CITY of NOVI CITY COUNCIL

Agenda Item 3 May 6, 2019

SUBJECT: Consideration at the request of Gateway Village of Novi, LLC, of the draft Third Amendment to Consent Judgment for the Gateway Village Development in the matter of Gateway Village of Novi, LLC v City of Novi, and authorization for the City attorney to take all action to file the amendment with Circuit Court. The subject property is located in the northwest corner of Grand River Avenue and Meadowbrook Road in Section 23. The amendment is required for approval of JSP 18-22 Gateway Townhomes of Novi to provide for a new style building for the final phase of the multi-family residential component of the development

JSP 18-22 GATEWAY TOWNHOMES OF NOVI

GRADING & PAVING PLAN

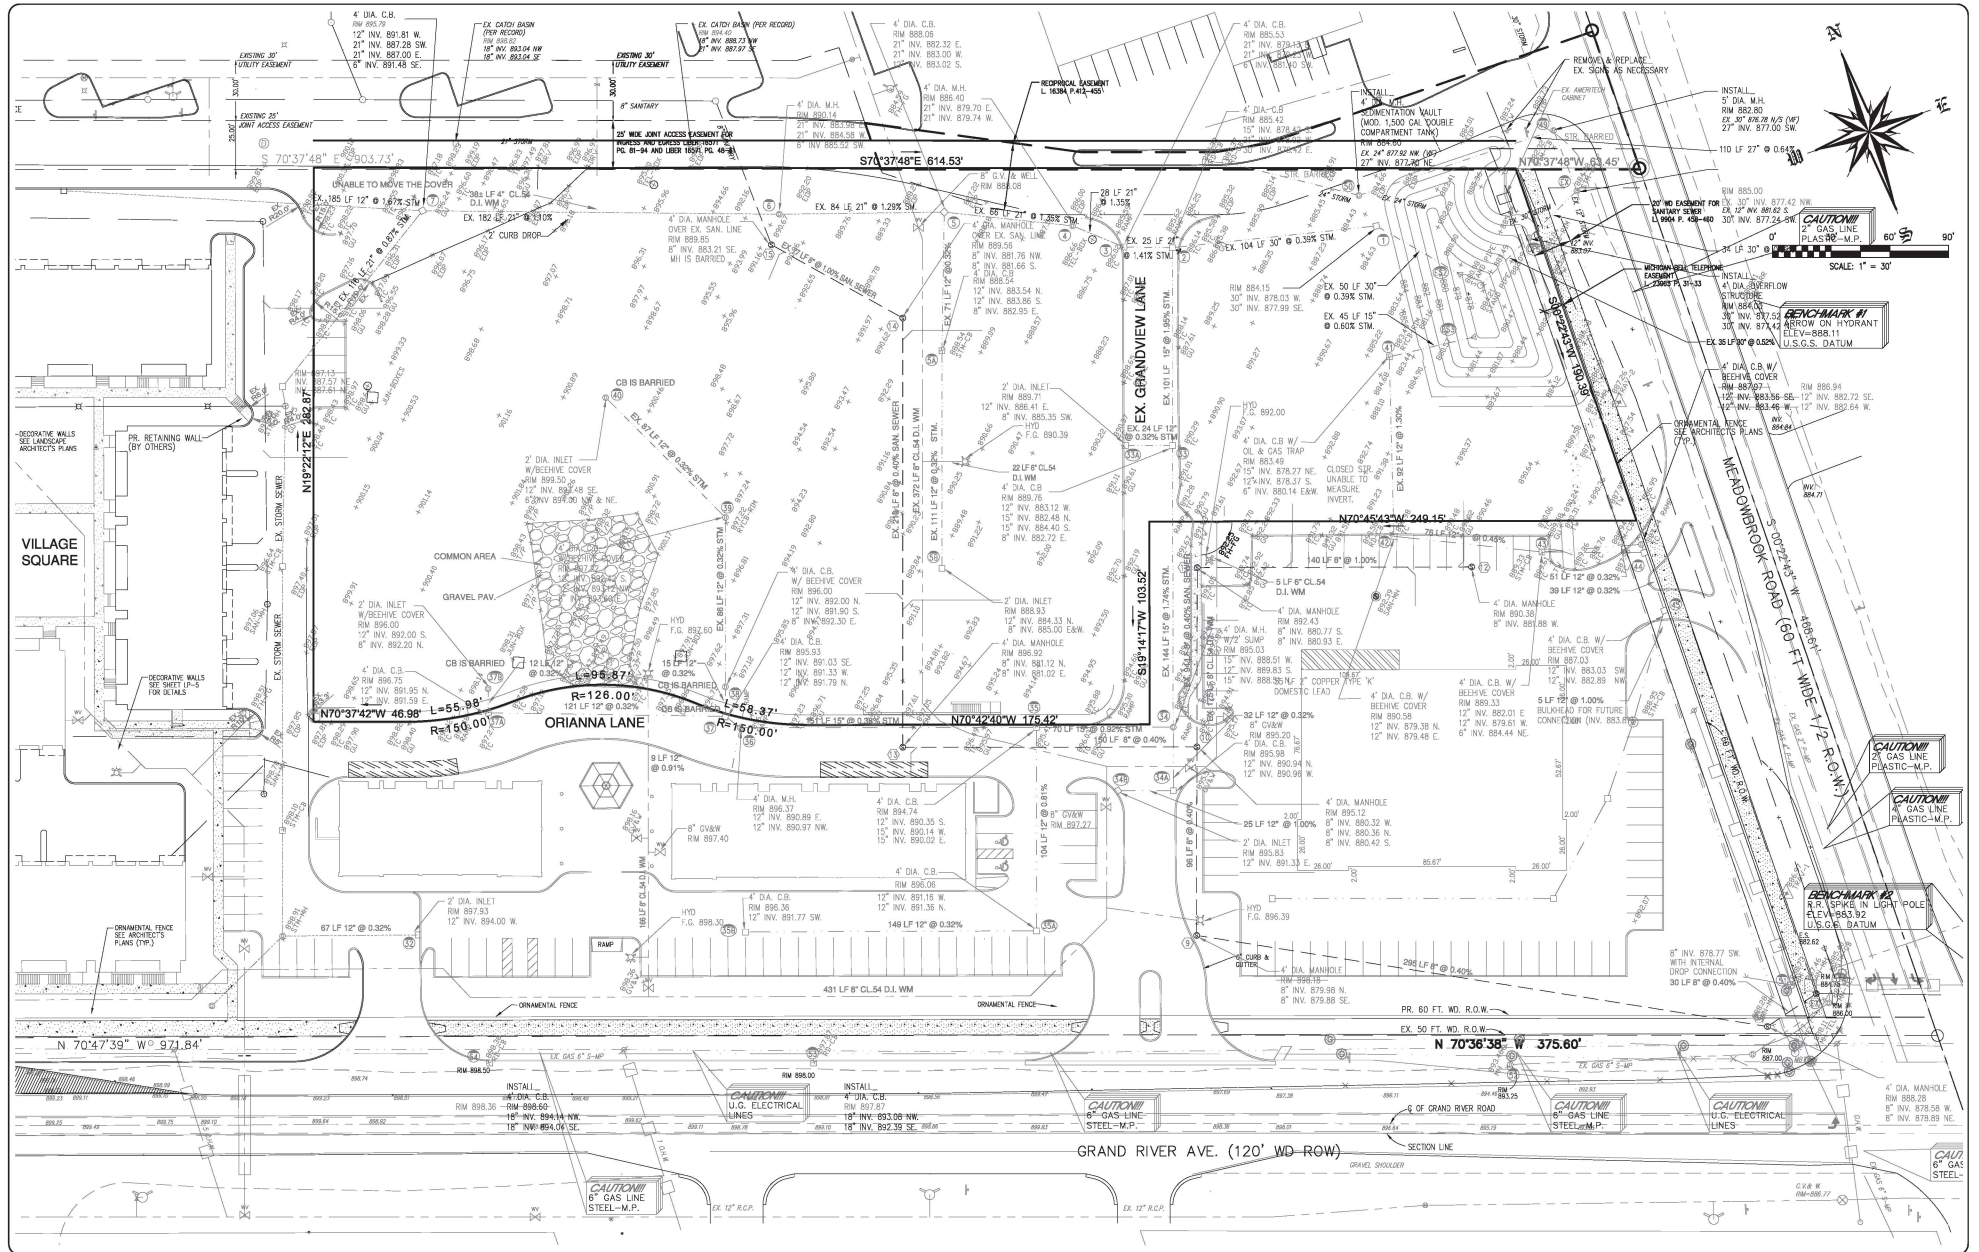
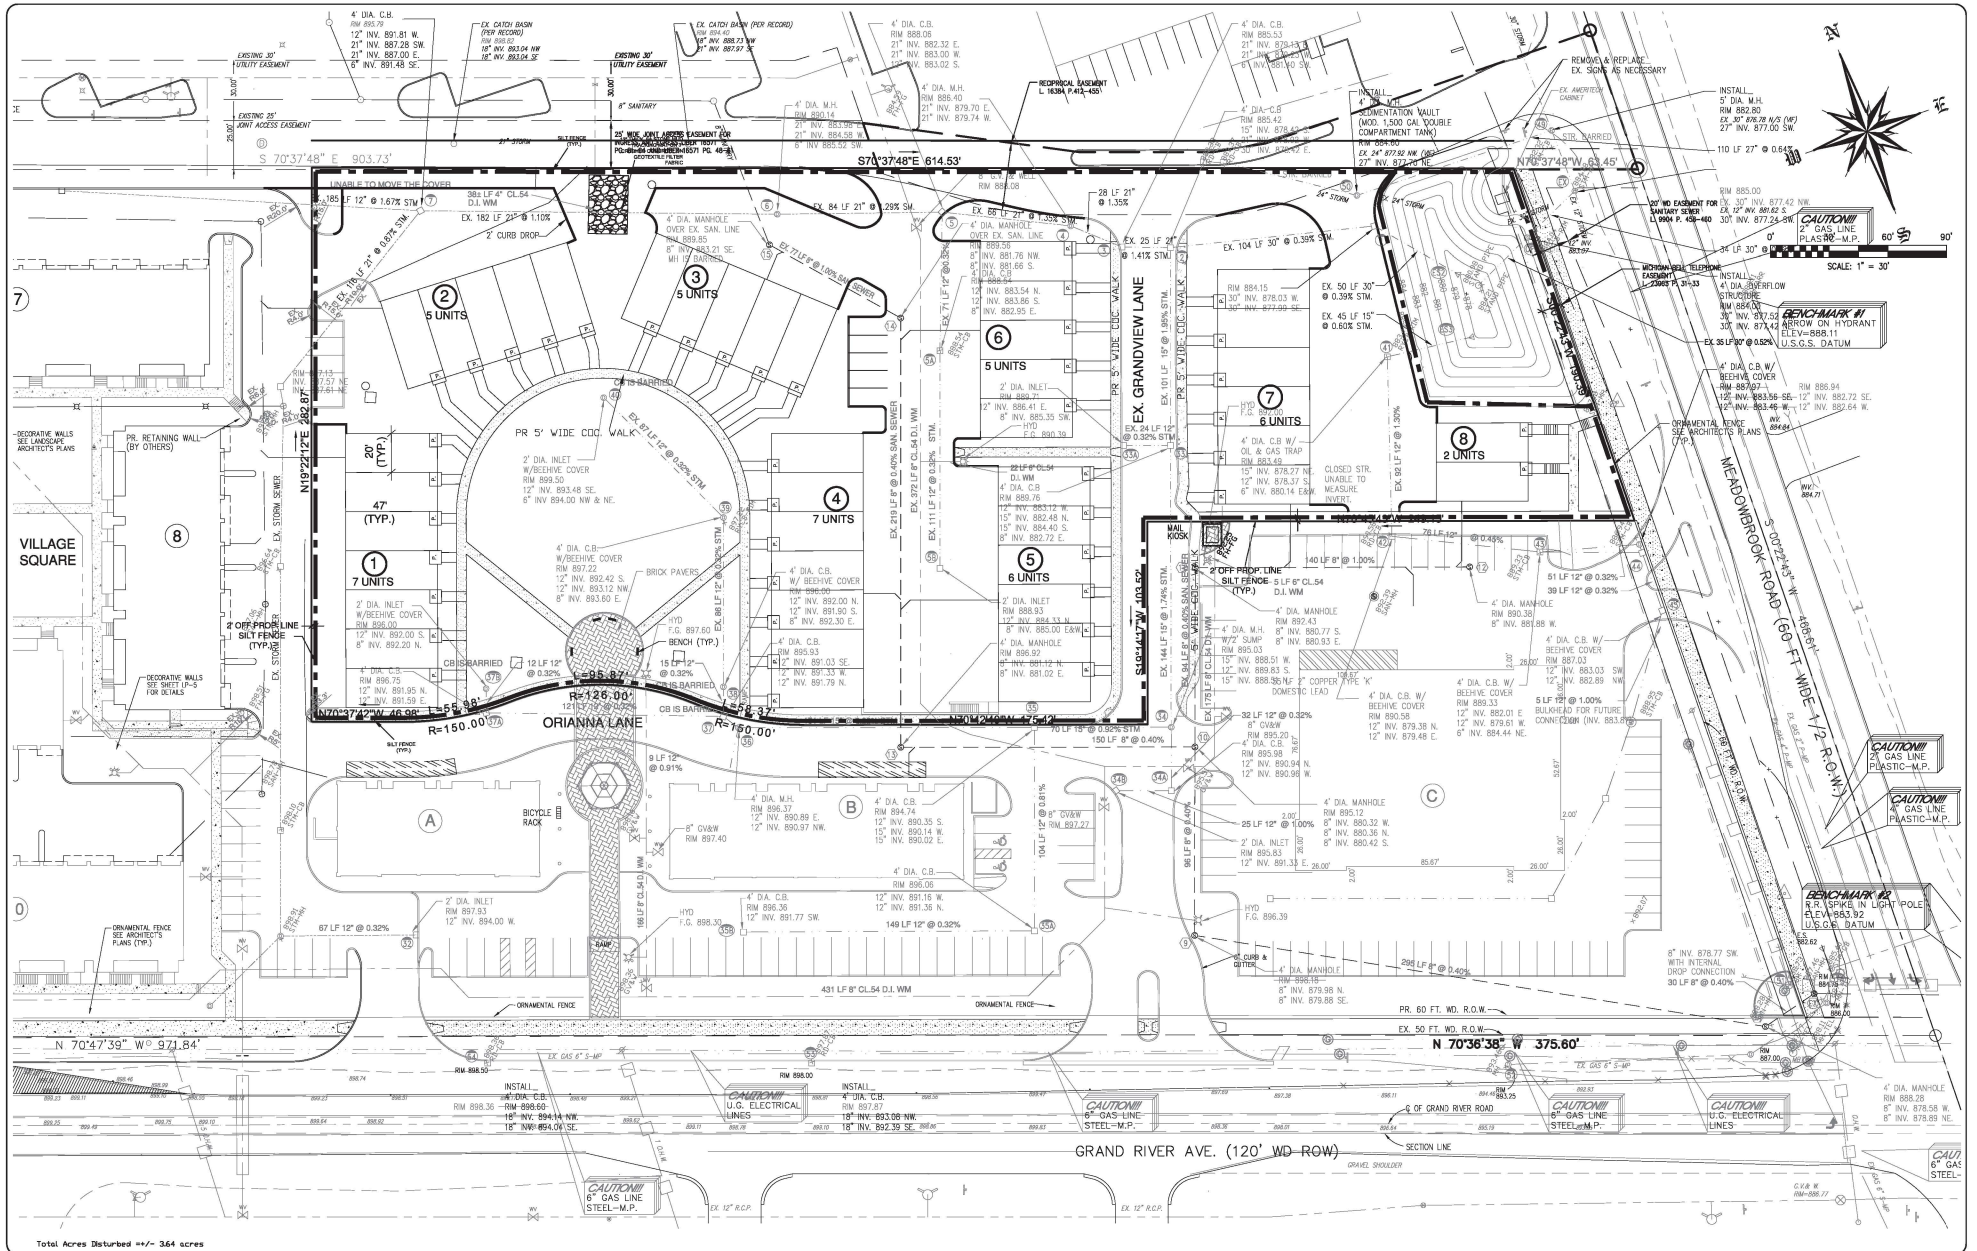
6. Provide a construction materials table on the Paving Plan listing the quantity and material type for each pavement cross-section being proposed.
7. Provide a utility crossing table indicating that at least 18-inch vertical clearance will be provided; or that additional bedding measures will be utilized at points of conflict where adequate clearance cannot be maintained.

- b. **The applicant should provide a sidewalk ramp detail in future submittals (MDOT R-28-J).** The applicant has provided a ramp detail on sheet 9, but dimensions and design features are not included. **The latest MDOT standard (R-28-J) should be included to replace the current ramp detail.**

1 PHOTOMETRIC SITE PLAN

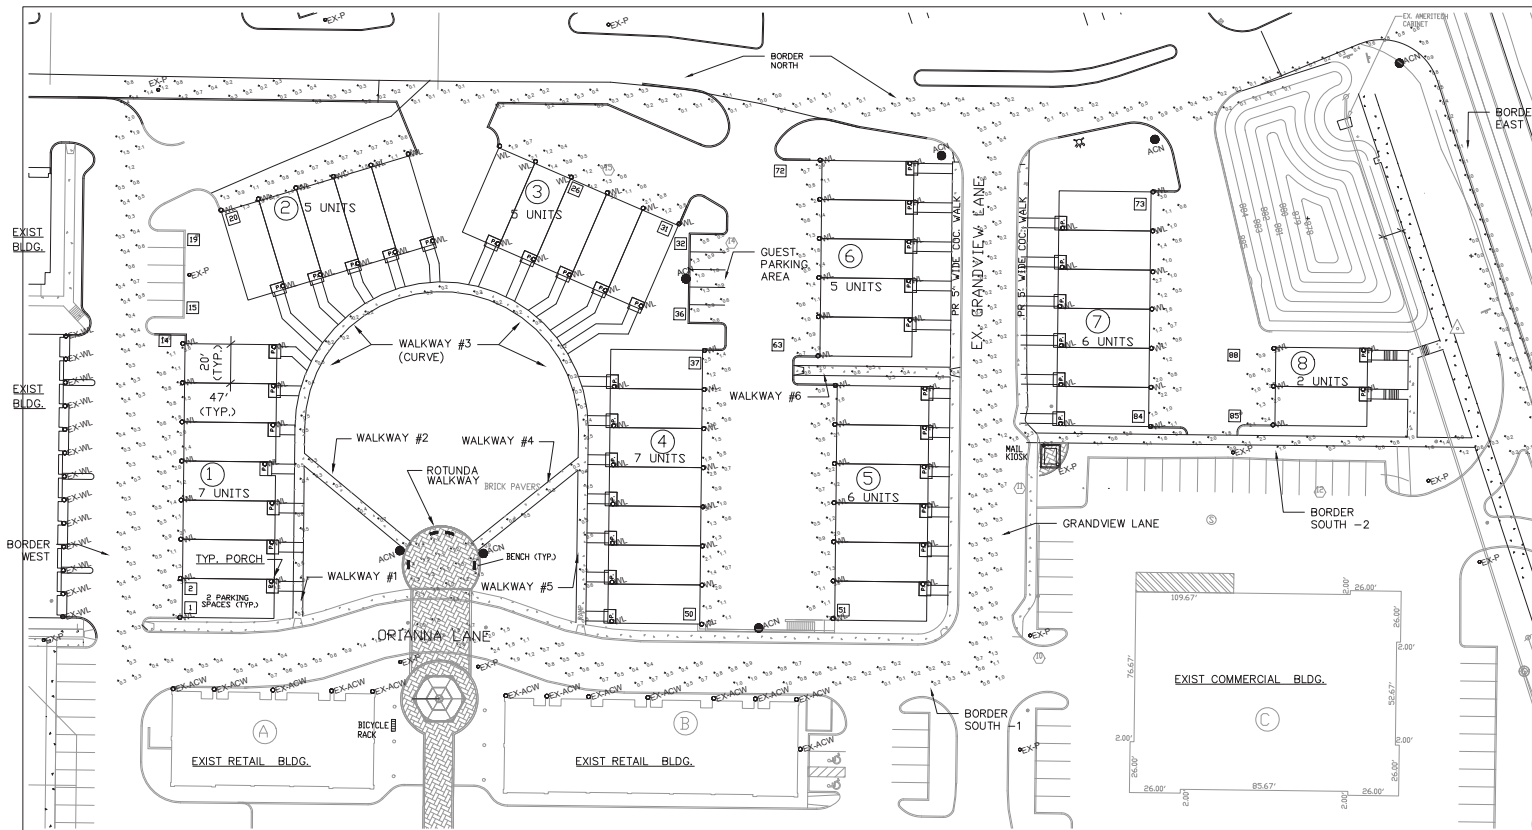
- d. Lighting (Sec 5.7): Provide details of lighting fixtures, locations, and a photometric plan to meet requirements of Section 5.7 of the Ordinance for Final Site Plan review. See details in Planning Chart. **Deviations may be required due to spillover on the property line. Provide additional information with the revised submittal.**
